DOCUMENT 00 9113

**ADDENDUM NO. 2
12/2/25**

SPECIFICATION NO. 26-11756-C

**SANTA FE TRACKBED TO PARK CONVERSION
REMEDICATION, DEMOLITION AND PERIMETER FENCING**

G2.01

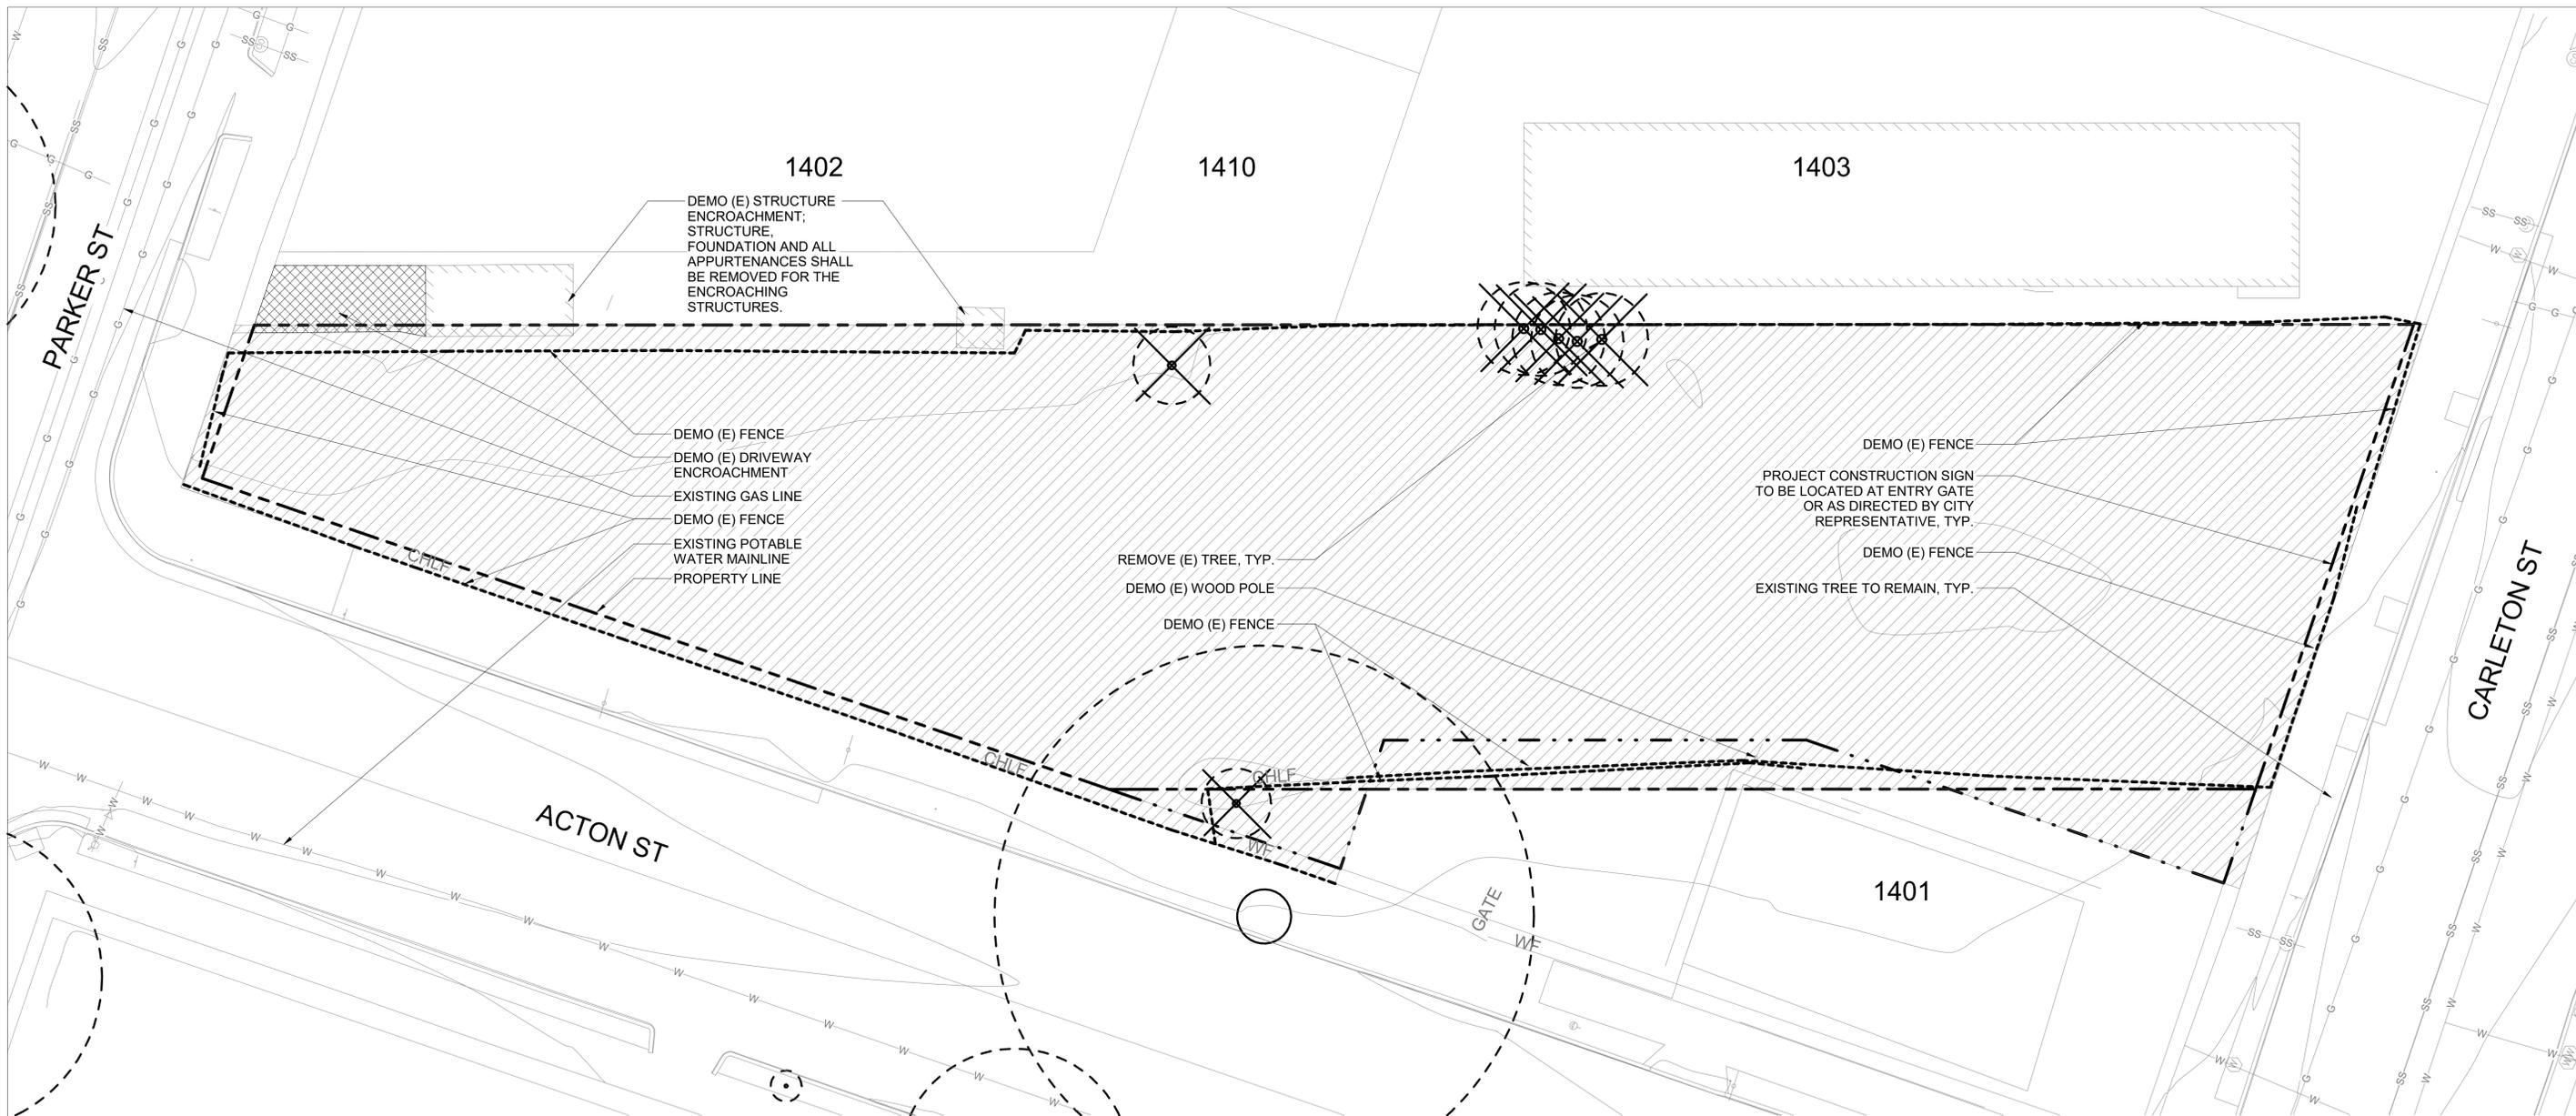
1. Replace the following sheets with the updated sheets:
 - a. G2.01 Demolition Plan – Blake to Parker – Added demolition notes
 - b. G2.02 Demolition Plan – Parker to Carleton – Added demolition note
 - c. G2.03 Demolition Plan – Carleton to Derby – Added demolition notes
 - d. G2.04 Demolition Plan – Derby to Ward – Added demolition note
 - e. L1.02 Materials Plan – Parker to Carleton – Revised grades and adjusted gate location along Acton Street.
 - f. L4.01 Details – Wood Fence – Revised detail notes and footing dimensions.
 - g. L4.02 Details – Chain Link Fence and Gates – Revisions to details.

**DETAILS - WOOD
FENCE**

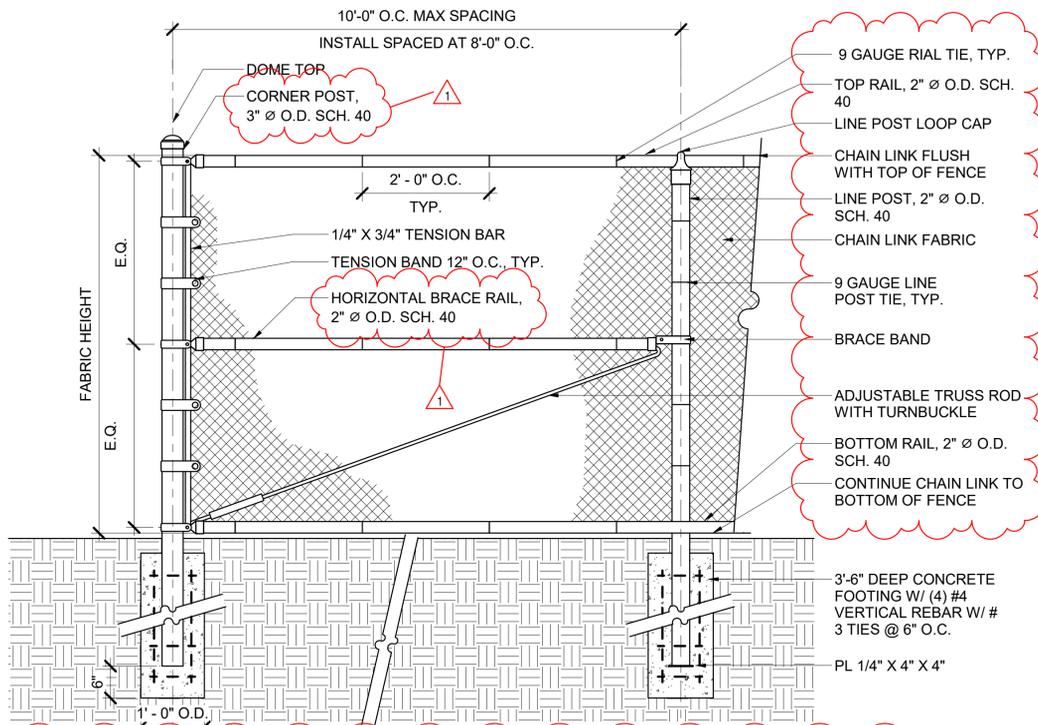
66. For wood fence atop vertical curb, what are the curb dimensions and reinforcement details?
Response See revised plan sheets in this bid addendum. Please refer to detail 1/L4.01 as noted in the Landscape Wall Type Legend of the Material Plan Sheets. "Section at Post in Vertical Curb" of detail 1/L4.01 provides curb dimensions and reinforcement details for wood fence atop vertical curb.

68. Please confirm whether the con-heart redwood fencing on L4.01 is to receive (a) both a penetrating oil and a separate anti-graffiti coating, or (b) a single penetrating anti-graffiti sealer; and identify approved manufacturer/products and required application sequence. Drawing L4.01 notes "coat con-heart redwood fencing with penetrating oil and anti-graffiti coating," which reads as two separate products. Section 06 2013 specifies construction heart redwood lumber and a wood coating "Micro-Seal with Graffiti Control" by Rain Guard or approved equivalent, but does not mention a separate penetrating oil product.

Response Micro Seal with Graffiti Control is the only finish to be applied to the wood fencing. See revised detail sheet L4.01 in this bid addendum.

1 CHAIN LINK FENCE
3/4" = 1'-0"

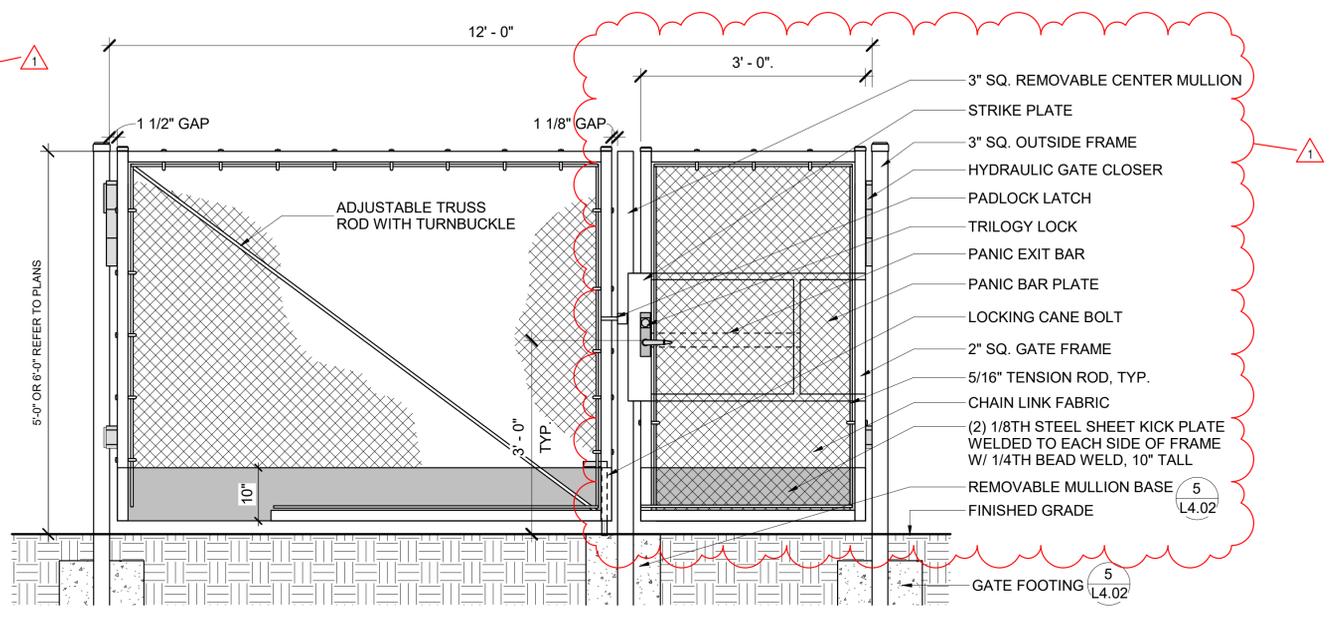
69. Please clarify the intended chain-link fence system, including whether 2" black vinyl-coated 2" diamond mesh without slats or 3.5" x 5" Priva-Max pre-slatted panels are required, acceptable mesh/slat colors, whether 9 ga fabric is acceptable in lieu of 11 ga, and required rail diameters.

Detail 1/L4.02 calls out "preslatted" (pre-slatted) fabric, Note 2 calls for 2" diamond mesh, and Note 4 calls for black mesh color, but the referenced Merchant Metals / Priva-Max pre-slatted product is 3.5" x 5" galvanized steel with limited standard colors (brown, beige, white, gray, redwood, green). It is unclear whether the Owner wants a 2" black vinyl-coated chain link fabric without slats, or a pre-slatted privacy system, and what color(s) are acceptable. Chain-link work is also governed by Section 32 3113 – Chain Link Fence and Gates and drawing L4.02. In addition, the details show 3.5" Schedule 40 top, horizontal, and bottom rails, which is atypically large and heavy compared with the 1-5/8" industry-standard rails and may create connection and handling issues. Clarification is needed for bidding and to confirm if 9 ga fabric (with or without slats) and standard rail sizes are acceptable.

Response Use 3" terminal posts with 2" line posts and rails and 2" 9 gauge black vinyl coated mesh with no slats. See revised detail sheet L4.02 in this bid addendum.

2 CHAIN LINK GATE - TYPE 1
3/4" = 1'-0"

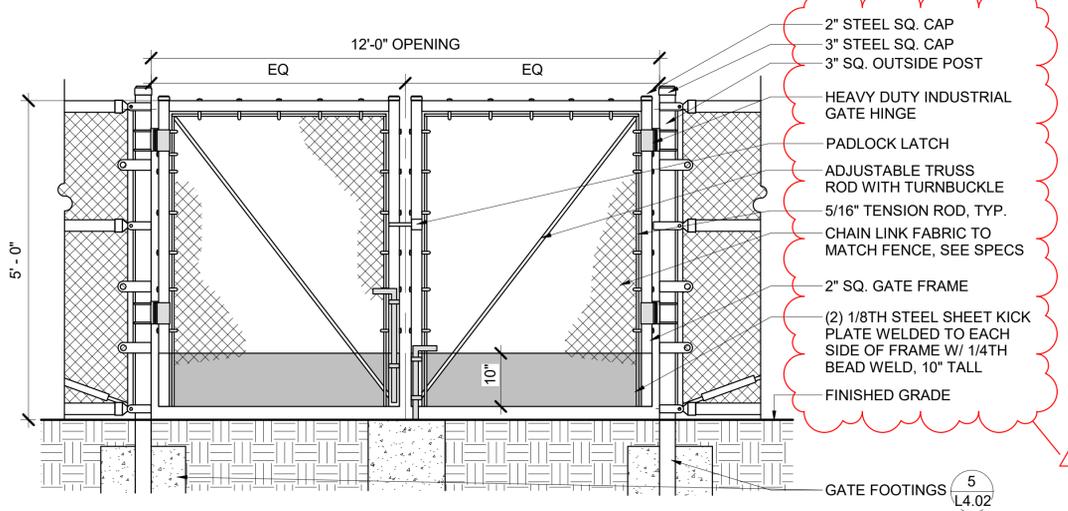
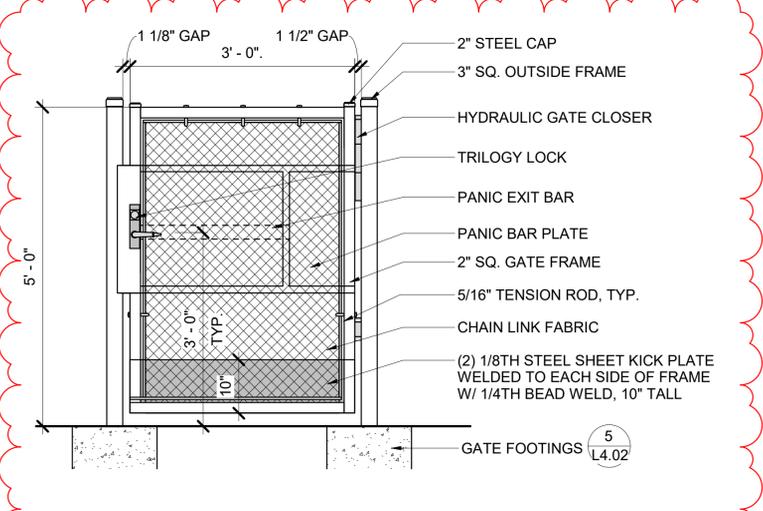
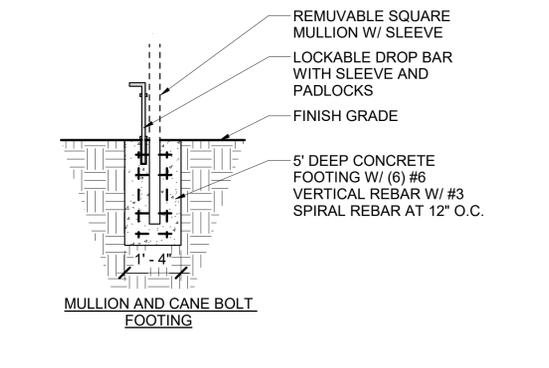
67. Do gates require specific hardware or locking mechanisms consistent with City standards?
Response All pedestrian gates shall have Trilogy battery powered lock. All vehicular gates shall have a padlock latch. See revised details 2, 3, and 4 on sheet L4.02 included in this bid addendum.
